Change No. 2

RTCA/DO-210D

# MINIMUM OPERATIONAL PERFORMANCE STANDARDS FOR GEOSYNCHRONOUS ORBIT AERONAUTICAL MOBILE SATELLITE SERVICES (AMSS) AVIONICS

### Change No. 2 to DO-210D

## FIGURE 2. RECEIVER SUSCEPTIBILITY

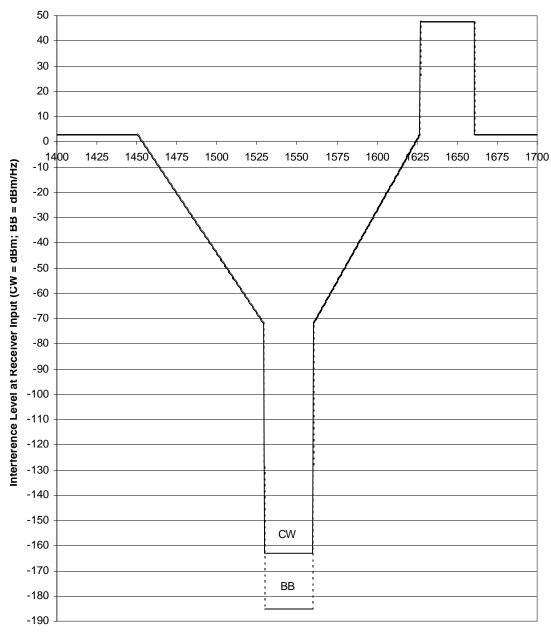
**1.** Section 2.1.9 of DO-210D and <u>Figure 2</u> were added via Change No. 1 to RTCA/DO-210D. Replace that former Section 2.1.9 and <u>Figure 2</u> with the following text for Section 2.1.9 and <u>Figure 2</u>:

A receiver meeting the requirements of this document will operate satisfactorily in the presence of interference at RF levels at the receiver's input port not exceeding the following tabulated levels. The RF levels in the frequency ranges near the SATCOM receive band are also illustrated in <u>Figure 2</u>.

Frequency Range	Maximum Interference Level
470 to 1450 MHz	+3 dBm
1450 to 1529 MHz	Decreases linearly in decibels from +3 dBm at 1450 MHz to -72 dBm at 1529 MHz
1529 to 1560 MHz	-163.2 dBm (CW interference)
1529 to 1560 MHz	-184.9 dBm/Hz (broad-band interference density)
1560 to 1626.5 MHz	Increases linearly in decibels from -72 dBm at 1560 MHz to +3 dBm at 1626.5 MHz
1626.5 to 1660.5 MHz	+47.8 dBm
1660.5 to 18000 MHz	+3dBm
